THIS REVISED SHEET C5.0
IS ATTACHMENT # 28 TO
ADDENDUM #1

NEW-PHOENIX-PRE-K-THROUGH-12-SCHOOL
 NEW-PHOENIX-PRE-K-THROUGH-12-SCHOOL
 12700-HWY.-39-BRAITHWAITE,-LOUISIANA-70040
 FEMA-PW-4987

ATTACHMENT
NUMBER 28
TO ADDENDUM
NUMBER ONE

C5.0

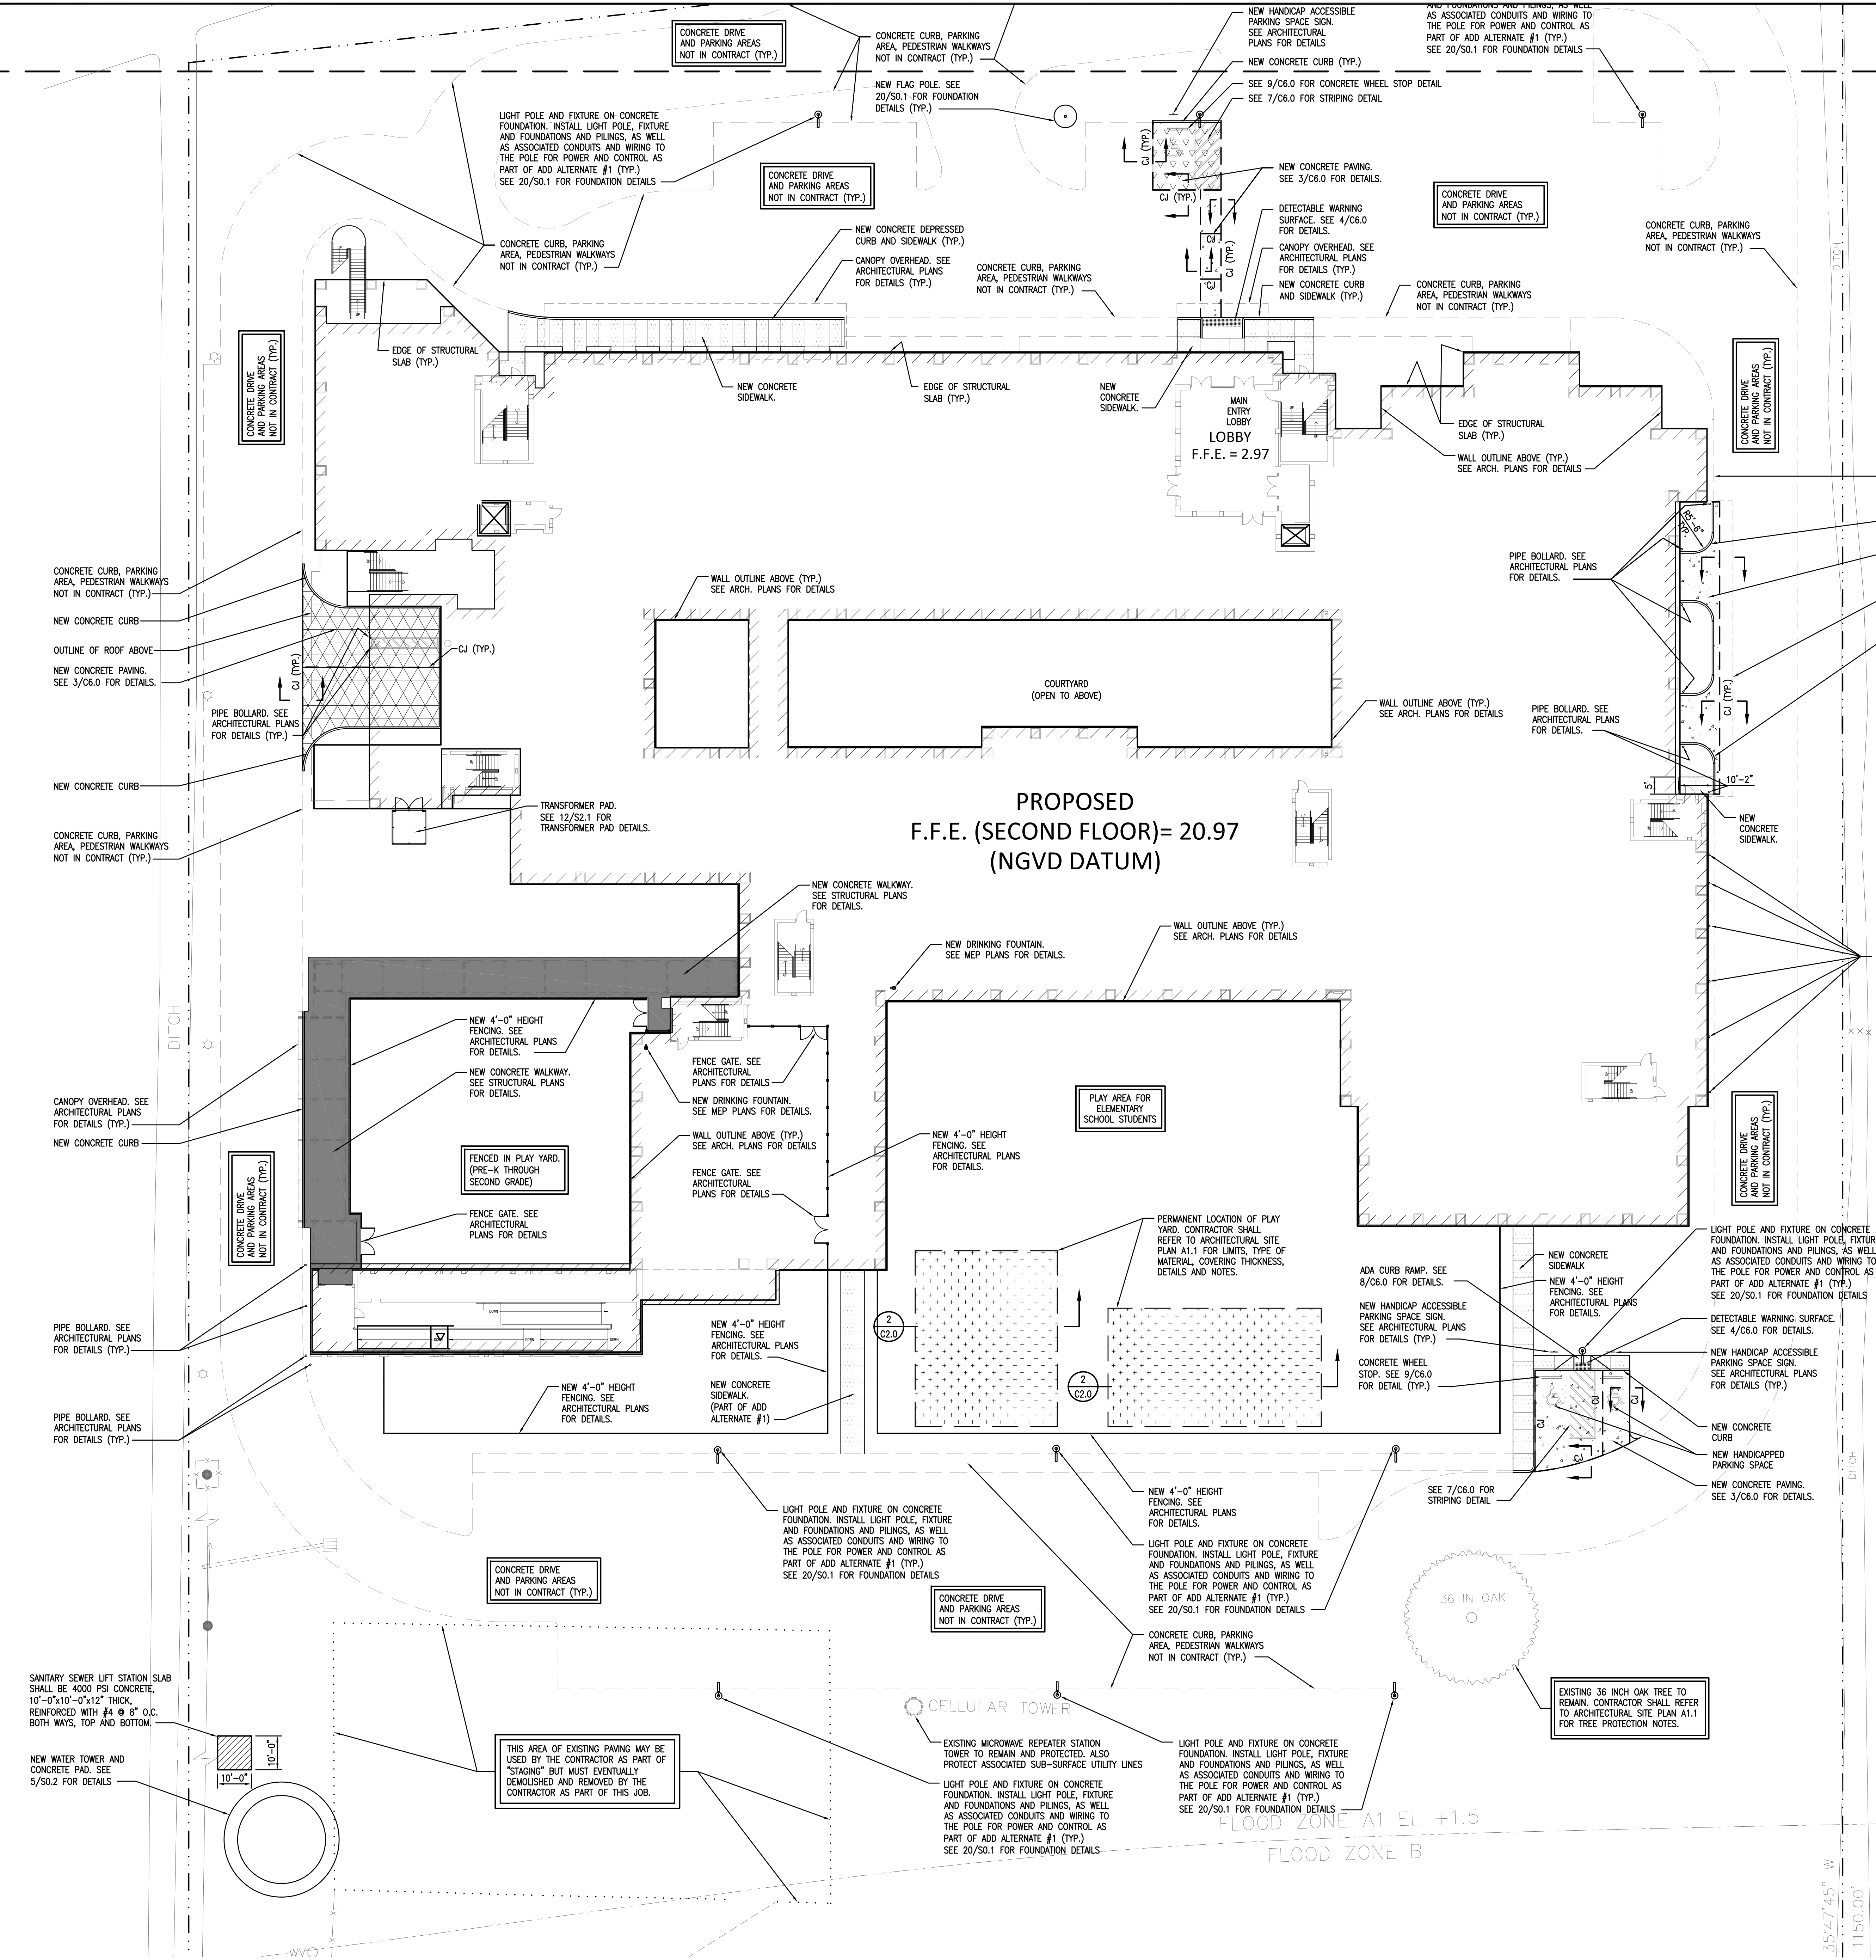
NOTE:
GRADES FOR PLAY YARD AS SHOWN ON GRADING PLAN, SHEET C2.0 ARE FINISHED ELEVATIONS. THE AMOUNT THAT THE SECTION OF CONCRETE PAVING TO BE DEPRESSED VARIES WITH THE TYPE OF FINISH COVERING TO BE INSTALLED. SEE ARCHITECTURAL PLANS FOR THE LIMITS OF PAVING, TYPE OF MATERIAL, COVERING, THICKNESS, DETAILS, ETC. CONCRETE PAVING SHALL BE DEPRESSED SO AS TO ACCOMPLISH FINAL GRADES AS INDICATED ON SHEET GRADING PLAN - SHEET C2.0.
